- A. Shorting in Phase-Maker Ignition System - 1 and 2-Cyl. 1971-72 Models
- B. "Troll Set" Knob Change - 1 and 2-cyl. 1972 Models
- C. Shift Cable Installation - Merc 1400 Model

- D. Chaffii of Ignition Module Leads - 1972 Merc 200
- E. Lubriplate 2C GL (50:1) Not Recommended
- F. Fuel Pump Diaphragm Kit Installation

Figure 1. Knob Diameter

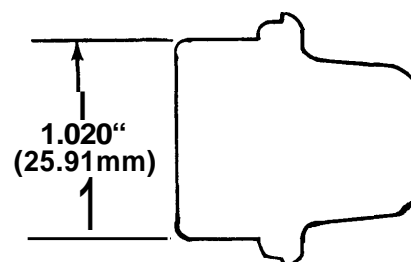
Should the "Troll Set" knob on 1972 Merc 200-110-75-40 models become loose or shake off, check the diameter of the knob, as shown in Figure 1. If the diameter is not as shown, replace the knob with Part No. A-62251.

A-62251 Throttle Handle Cap \$.55 U.S. List

Figure 2. Control Cable Latch

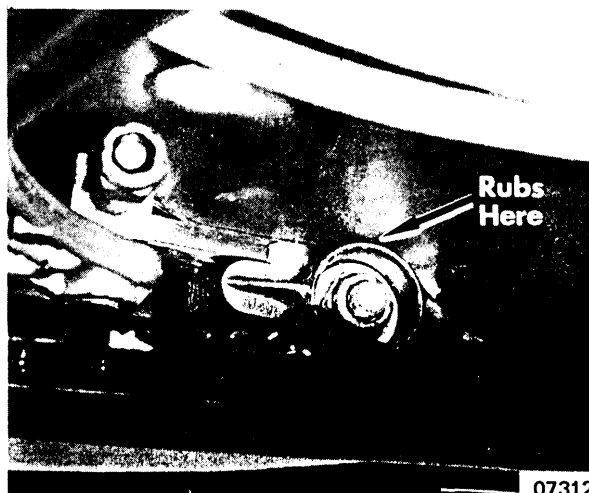
If the control cable latch (A-38279) rubs on the cylinder block (Figure 2), file or grind off the latch as shown in Figure 3.

Figure 4. Ignition Module Leads

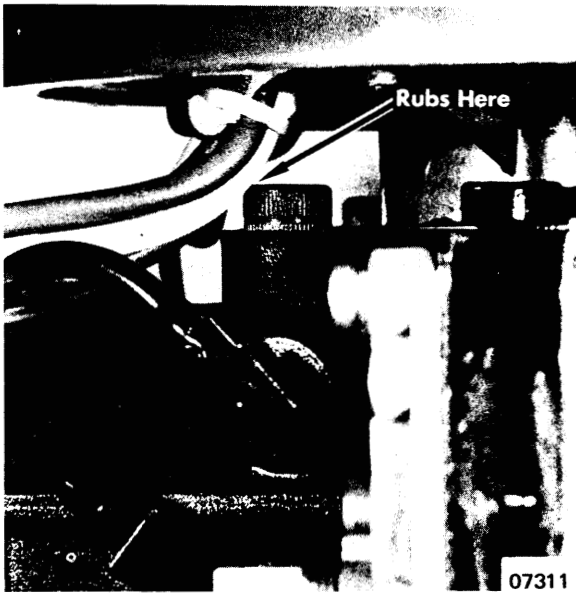
Ignition module leads on the 1972 Merc 200 may rub on the upper end cap right rear fastening screw. (Figure 4) If this chaffing is observed, remove sta-strap and re-install a new sta-strap, as shown in Figure 5, which will pull leads up and allow more clearance between leads and end cap.

Figure 6. Fuel Pump Gaskets

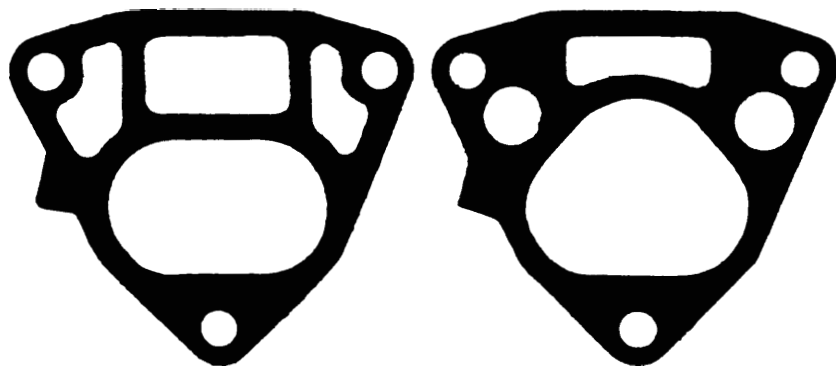
There have been numerous occasions on which the wrong fuel pump diaphragm kit was installed on an outboard. Figure 6 portrays the differences in fuel pump gaskets and lists the models on which they are used.

A-55278A2
DIAPHRAGM KIT
Morc 800 Single Pump

A-55278A1
DIAPHRAGM KIT
Morc 400
Morc 800 * Dual Pumps
Morc 1150 * 1350 * 1400
